AGENDA
Historic Yorktown Design Committee

SUBJECT: Application No. HYDC-260-24; Yorktown Beach Hotel, 508 Water Street

This application, submitted by Yorktown Beach Hotel, seeks approval for a new black metal rooftop railing at 508 Water Street. The railing would be added to ensure the safety of guests using the proposed historical observation deck, which would encompass approximately 18% of the roof. The structure was built in 1965 and is considered a Non-Contributing Building.

OBSERVATION DECK PLAN

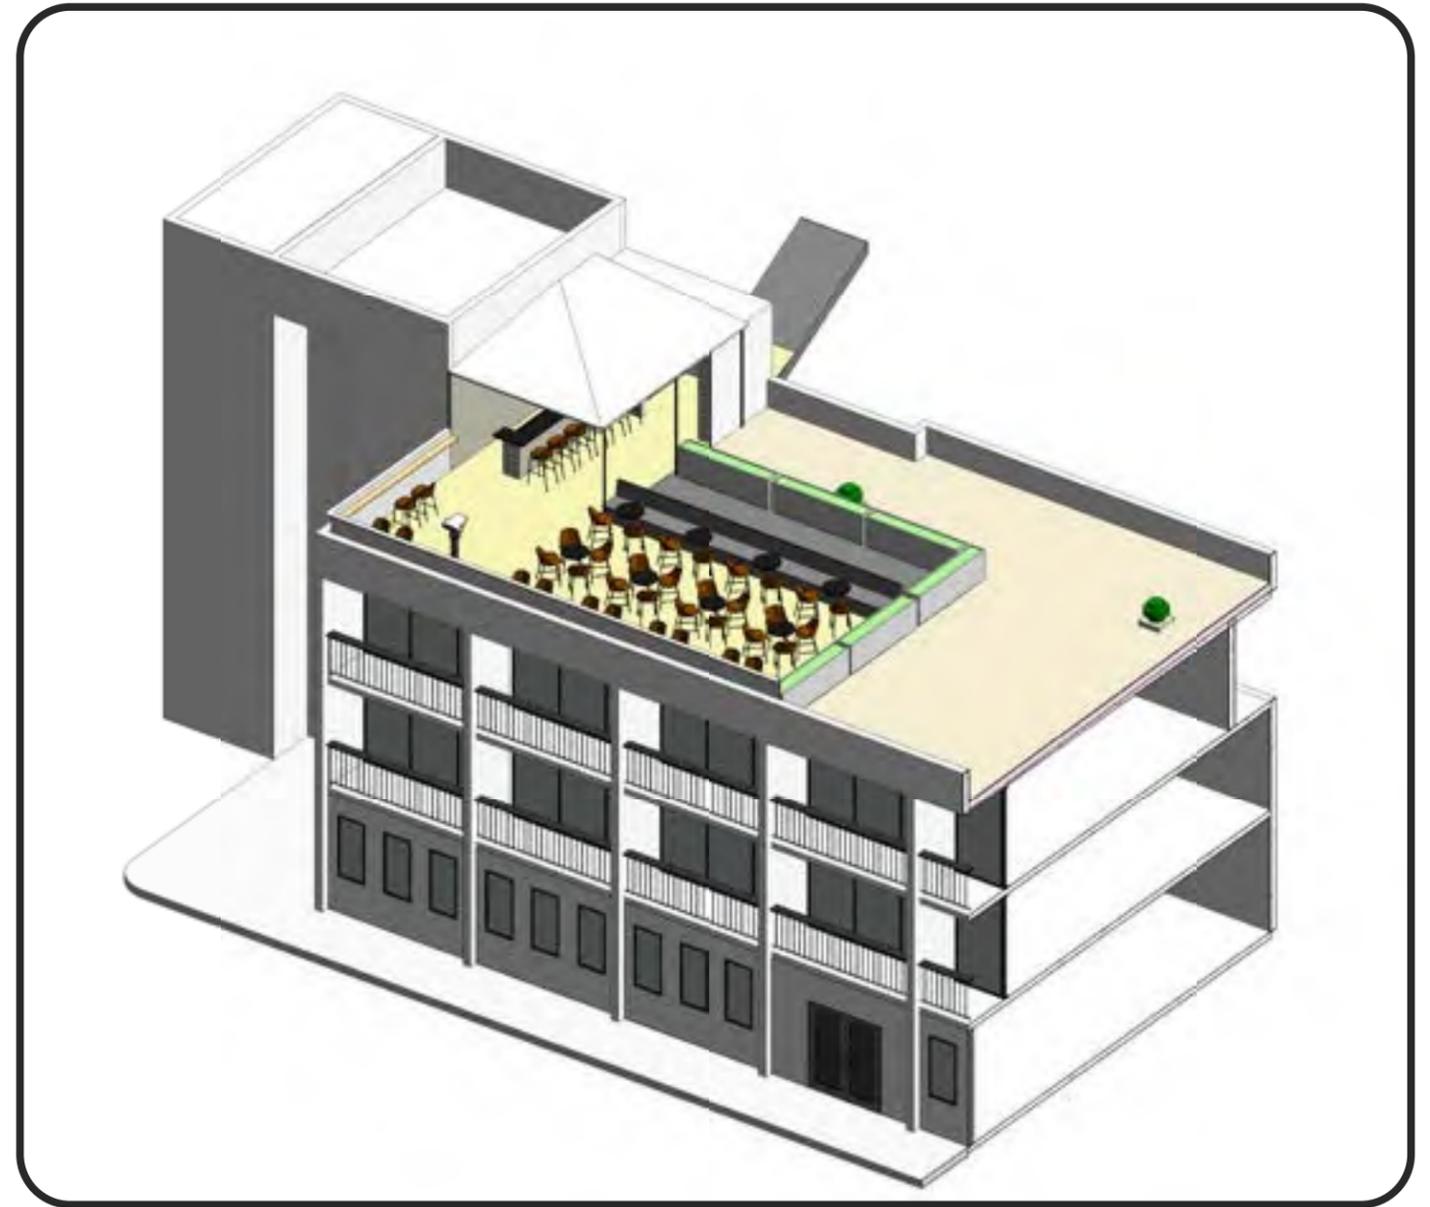
Standard	Comments
<u>II. The Waterfront</u> <u>B. Site Planning and Landscape Alterations</u>	
1. Views Scenic and pleasant views to and from the York River and vantage points such as the Coleman Bridge, the bluffs, and	The proposed railings will not obstruct any views of the river from adjacent properties but will contribute to the creation of a scenic

<p>other significant sites should be protected and maintained. The effect of new construction on such views, and on views from surrounding properties, will be considered on a case-by-case basis. Views objectionable in the Historic District from such vantage points should be screened whenever possible.</p>	<p>vantage point of the river. The black railing blends in with the building and would not be obtrusive to those viewing from the beach or the river.</p>
<p><u>C. Architectural Additions, Alterations and New Construction</u></p> <p><u>2. Architectural Elements</u></p>	
<p>b. Building Color</p> <p>(1) Paint colors for all exterior surfaces (excluding fences) should be selected comprised of a color or colors from the Yorktown Color Palette, as defined in Appendix 3, Glossary. Other colors may be proposed and will be considered on a case-by case basis.</p>	<p>The exterior of the building has two colors—white and black, both of which are in the Yorktown Color Palette.</p>

<p>g. Porches and Balconies</p> <p>(4) Railings should have top and bottom rails and balusters should have a vertical orientation. Wood or wrought iron is an appropriate material for railings.</p>	<p>The railing would be one solid and continuous piece of black metal without balusters; however, the parapet wall would obscure the bottom portion of the railing. The railing would extend one and a half feet (1.5') above the wall and would be the only visible portion.</p>

While the railing would lack balusters, staff believes the proposed rooftop railing fits the character of the building. The railing echoes the look of the balcony railings, which have thick black top rails. Staff believes the proposal is substantially consistent with the Design Guidelines and will improve the overall aesthetic of the building. Therefore, staff recommends approval of the rooftop railing with the design and specifications/details as submitted by the applicant.

Window Brand Preservation
Model # Single Casement - 9071
Quantity 5
Color Colored Exterior Lamination Black Custom

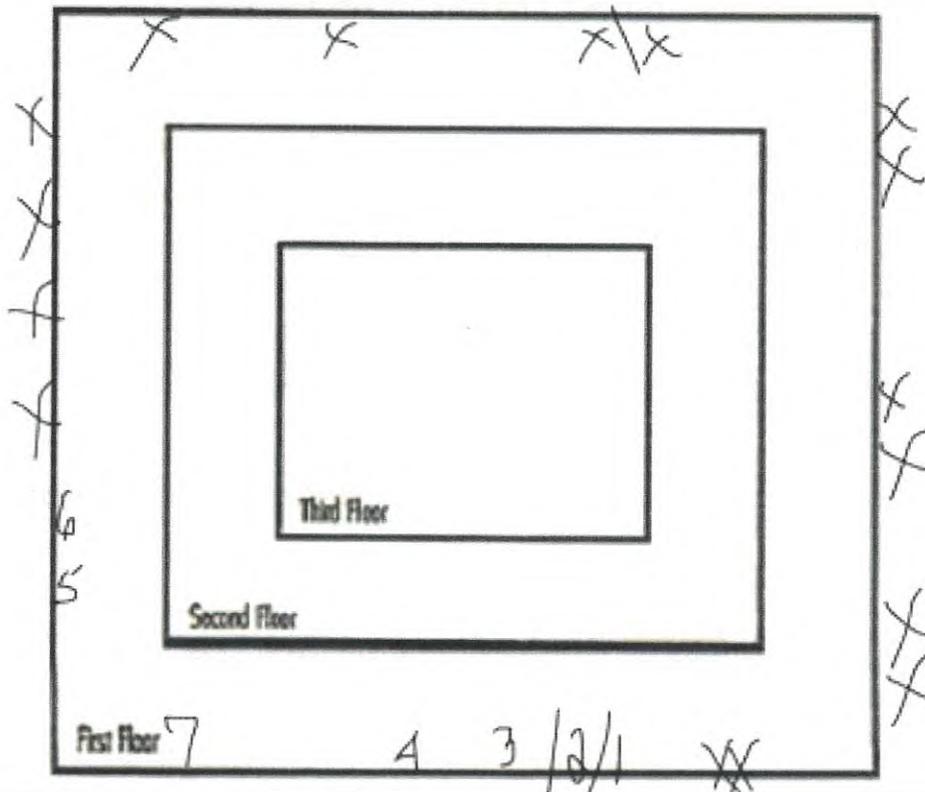
In staff’s opinion, the proposed divided-light windows would be more characteristic of a contributing building in the historic core than the existing windows. The proposed black color of the windows would change the overall appearance of the home, given the existing windows are white, but staff believes the color is appropriate and it was selected from the Yorktown Color Palette. The Guidelines require all new construction buildings to have double-hung windows but for contributing buildings, like the subject house, the Guidelines recommend against casement windows *only* if they are not compatible with and characteristic of the particular architectural style of the original structure. Staff believes casement windows would be appropriate for the style of the house.

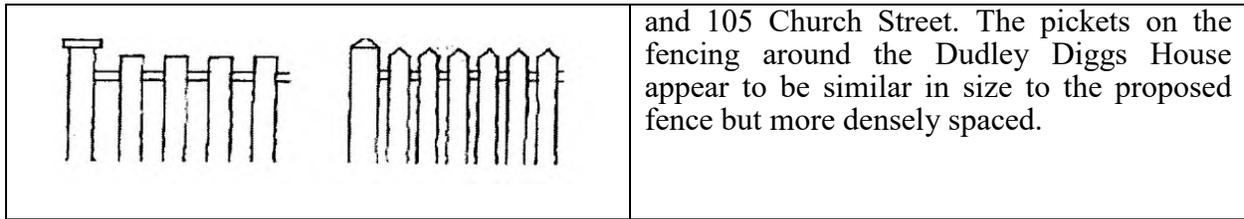
<p>APPENDIX 2: ILLUSTRATIONS AND DIAGRAMS</p>	
<p>3. Fences</p>	
<p>Fences should be simple in overall design, painted white, between 36"- 48" in height, and have appropriately sized and spaced pickets with a simple, geometric profile. Pedestrian entry gates should be of the same material, color, and general design as the fence.</p>	<p>The proposed fence is simple in design and constructed of white vinyl. The pickets have a simple geometric profile. The proposed fence packaging says it is both three feet (3') in height and thirty-four inches (34") in assembled height. The pickets appear to be narrower and/or have more space in between them than the picket fencing around the Post Office, Swan Tavern, Somerwell House, Chischiak Watch, and the homes at 114, 112,</p>

Wooden white-painted picket fencing is characteristic of the Historic Core in Yorktown, given the National Park Service has installed long stretches of it in front of the historic buildings on Main Street. The Design Guidelines support a wooden white-painted picket fence but allows the HYDC to review cases on an individual basis. The proposed fence is similar in color and style (white picket) but dissimilar in material (vinyl), size and spacing. The vinyl has a smooth finish and the pickets are narrower and/or more distantly spaced than many other white picket fences in the Historic Core. In staff's opinion, the proposal is not consistent with the Design Guidelines. Accordingly, it is recommended that the Committee deny the proposal as inconsistent with the Guidelines. If the HYDC wishes to approve the application, staff has recommended the approved be subject to the following conditions:
